STATE OF MAINE
DEPARTMENT OF TRANSPORTATION
16 STATE HOUSE STATION
AUGUSTA, MAINE
04333-0016

July 21, 2008
Subject: **Portland**
Federal Project No: STP-1054(400)X
Pin No: 010544.00
Amendment No. 1

**Portland
STP-1054(400)X
Highway Reconstruction
Warren Avenue
July 18, 2008**

STA. 2+319 L+
 Vault for M.H.

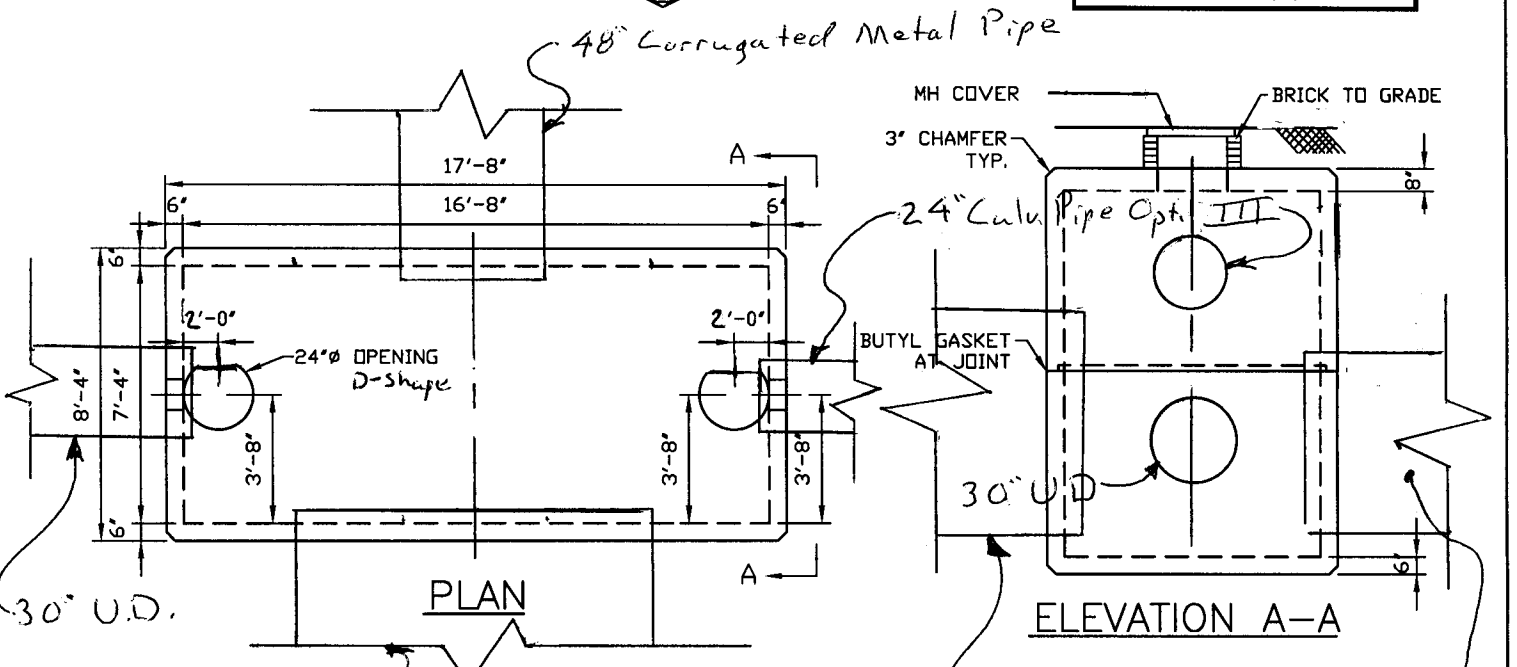
In the Bid Book (page 82), **REMOVE** "SPECIAL PROVISION, SECTION 604, MANHOLES AND CATCH BASINS, (Precast Concrete Tank)", 1 page dated April 3, 2008 and **REPLACE** with the attached, new "SPECIAL PROVISION, SECTION 604, MANHOLES AND CATCH BASINS, (Precast Concrete Tank)" 1 page dated July 17, 2008 and the two attached diagrams dated August 14, 2007.

Traffic Control Plan
 Detour Signing - Portland
 Warren Avenue PIN 10544.00

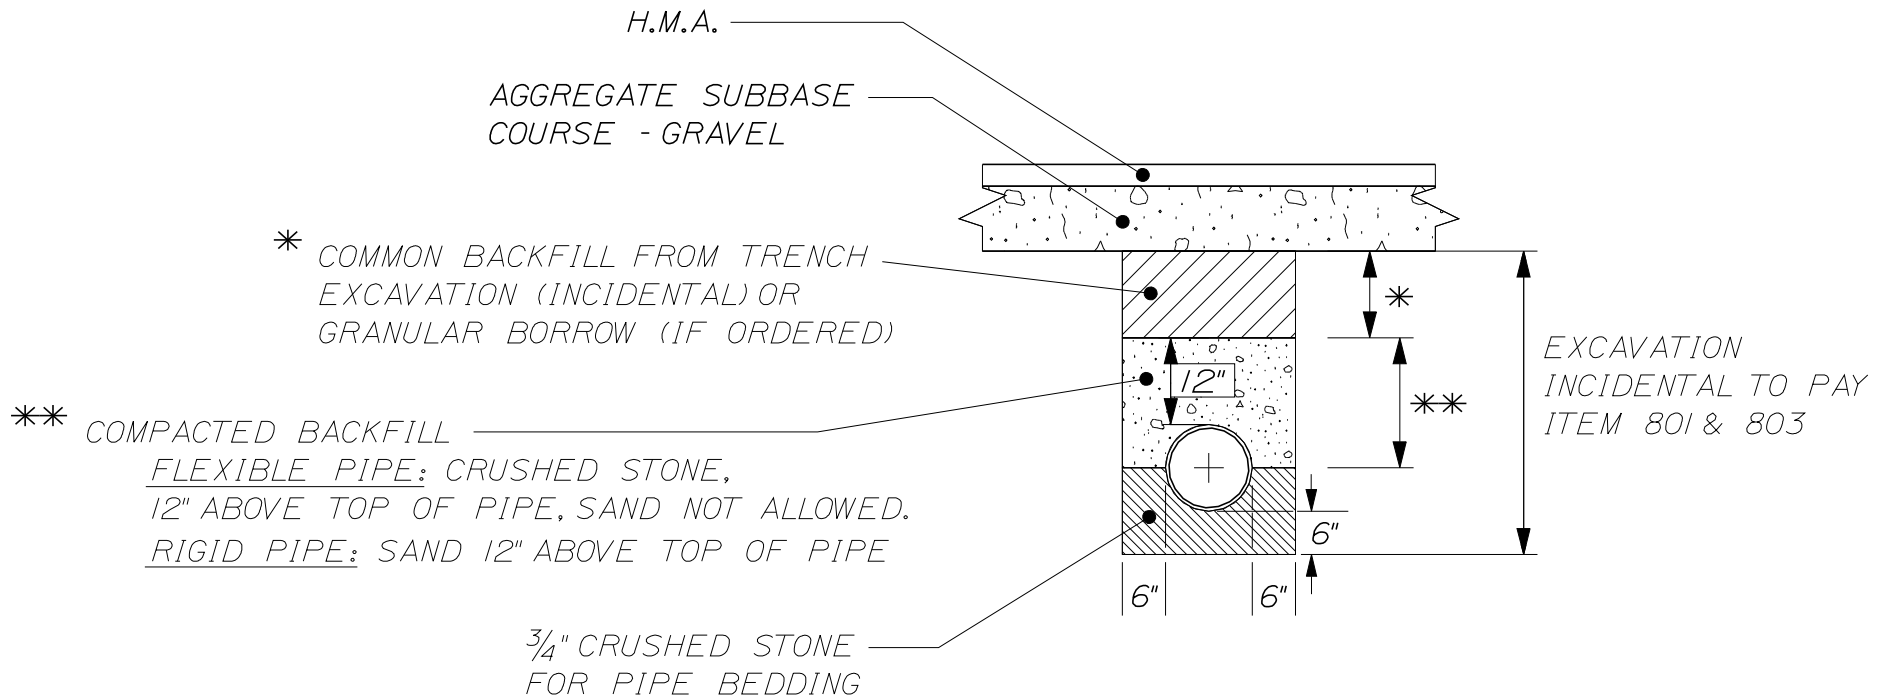
In the Bid Book, **REMOVE** the page following page 102, a partial diagram depicting the Traffic Control Plan Detour Signing and **REPLACE** with the attached, complete Traffic Control Plan Detour Signing diagram.
